Final Environmental Impact Statement

Volume II – Responses to Comments

Big Stone II Power Plant and Transmission Project

Lead Agency:
Western Area Power Administration

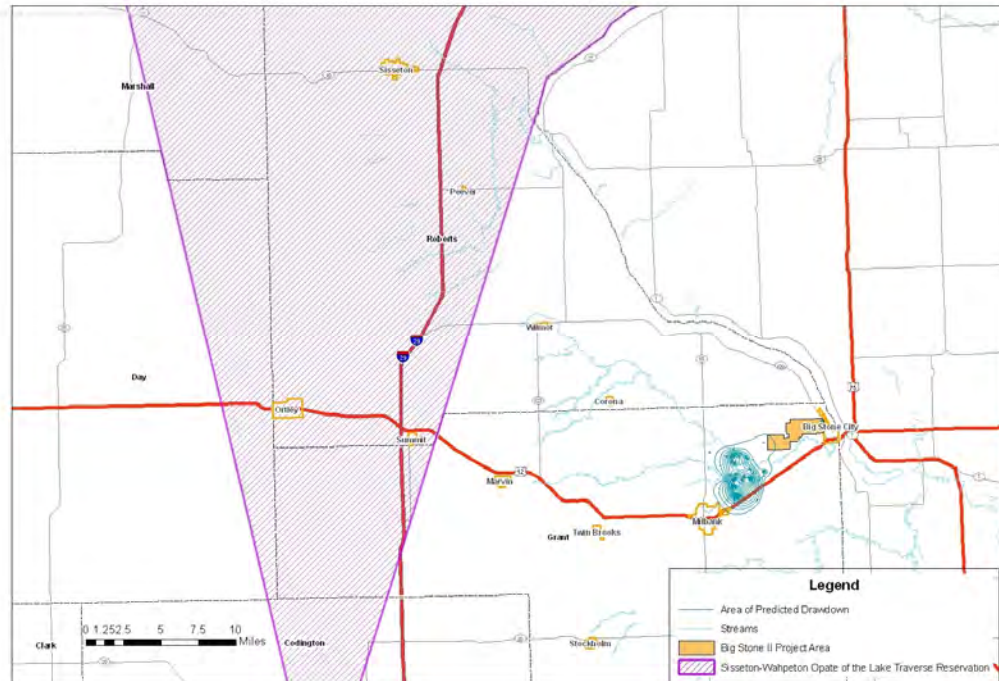
Comment Number	Name	Comment Summary
DEIS Comments		
No comments received.		
SDEIS Comments		
ST-1am	SWO	“If the Reservation is completely within the defined airshed for the proposed project, why did the DEIS not address the potential for disproportionately high adverse environmental effects on the minority population of the Reservation? The spirit and intent of CEQ’s environmental justice guidelines were not followed in this case.”
SPH-1b	Public Hearing Milbank, SD Myrna Thompson	“I would like to say that the tribe is very concerned and still does oppose the project, because we have no information on long-term environmental impacts over time, as well as the health impacts to our -- not only our people, the human factor, as well as the vegetation and the water, the air quality.”

Response: The figure below shows the location of the Lake Traverse Indian Reservation of the Sisseton-Wahpeton Oyate (approximately 23 miles west of the proposed Big Stone II plant) in western Grant and Roberts counties. The figure shows the area of maximum drawdown expected during pumping of the Veblen Aquifer (also demonstrated in Figure 4.2-2 of the Final EIS). Also refer to the “Groundwater” discussion (“Groundwater Pumping and Production Impacts” subheading) in Section 4.2.2.1 of the Final EIS. The figures and discussion indicate that no impacts would occur to aquifer units at the Lake Traverse Indian Reservation. Refer also to the “Wetland/Riparian Areas” discussion (“Well Operations” subheading) in Section 4.4.2.1 of the Final EIS, which indicates that no impacts to wetlands or other surface waters would occur at the Lake Traverse Indian Reservation as a result of groundwater pumping. Also, see the Response to Comment T-1c (addressing air quality effects), in Section 10.2.1, above. Finally, the Final EIS has been updated consistent with CEQ’s environmental justice guidelines. Except for the uncertainties in determining the effects associated with mercury emissions noted above (see Comment T-1c), there would be no unique environmental effects on the Lake Traverse Indian Reservation from construction and operation of the proposed Big Stone II plant.
